From: Chanel Hargrave
To: Michele Schitto-Sabooschi
Subject: RE: BUN60444618 - 1799A Great South Road, Drury
Date: Friday, 11 April 2025 2:51:34 pm
Attachments: [mshc@11.png](#)
[mshc002.png](#)

Section 92 Further Information Response: Vernon Developments – 1799A Great South Road– BUN60444618 (DIS60444619 and LUC60444660)

ATTACHMENT A: SECTION 92 RESPONSE TABLE

Section 92 Response Table - Vernon Developments Land Use / Discharge Consent		
RFI #1 7/04/2025		
Number	Council Request	Response – 5/08/2025
RESOURCE CONSENT - BUN60444618		
Application Plans		
1	<p>For clarity, please provide a site plan that shows all existing metalled areas on the site and quantity the total impervious area for which stormwater discharge consent is being sought. Please also identify any existing metalled areas that are proposed to be uplifted, to avoid ambiguity going forward.</p> <p>As part of the above, please revise the Overall Stormwater Plan J2224-6 to show all existing and proposed impervious areas on the site, including the area earmarked for Aaron’s contracting in the north-western part of the site.</p>	<p>Please refer to the updated engineering plans in Appendix O, referenced C-502-03 - Curre

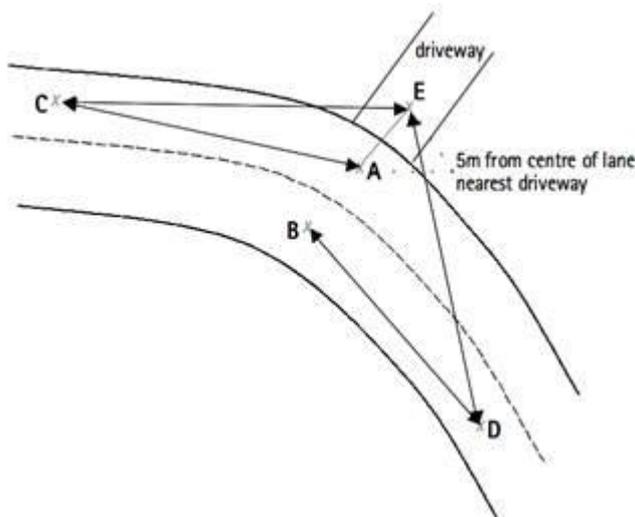
- 4. The section 4.4 of the AEE prepared by TSC states that the majority of the vehicles will enter and exit the site via right turn in and left turns out. Please provide revised tracking curves for the largest size of the vehicles accessing/exiting the site. This information is required to determine the width of the vehicle crossing and the driveway, ensuring safe two-way vehicle movements can be achieved.**

The tracking plans prepared by TSC show an articulated truck plus a 6.3m van entering and exiting at the same time. The majority of the vehicles entering and leaving the site will do so within limited time frames and will typically be entering or leaving at similar times. The potential for two heavy vehicles passing each other at the entrance is very small.

Figure 1: Showing vegetation plot locations and resulting assessment of area dominated by hydrophytic vegetation (assessment carried out 16th January 2025)

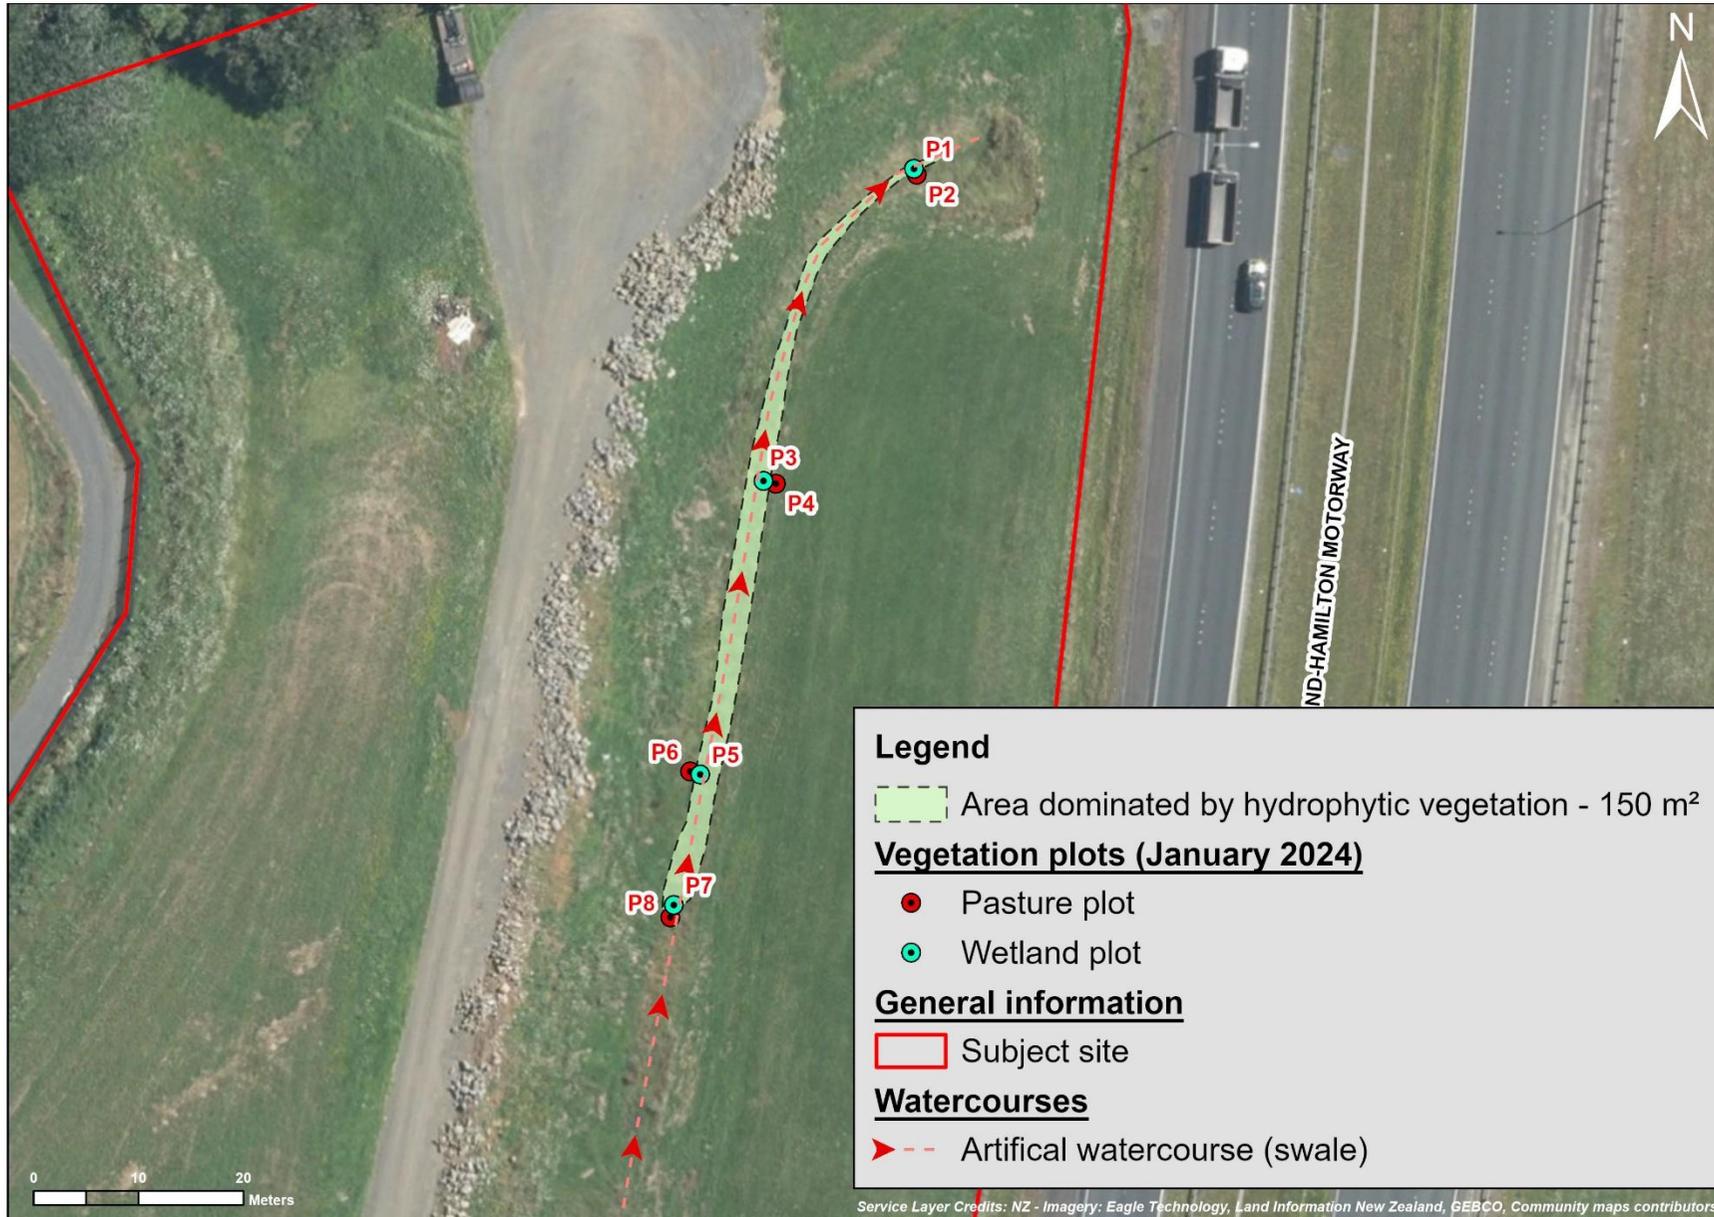
To provide further information to Council, the results of a rapid wetland delineation assessment during a site visit on 16 January 2025, following the Ministry for the Environment’s *Wetland Delineation Protocols* (MfE, 2022) are provided within this addendum memo. The results of this assessment are presented in Figure 1, Table 1, and Table 2 of this report.
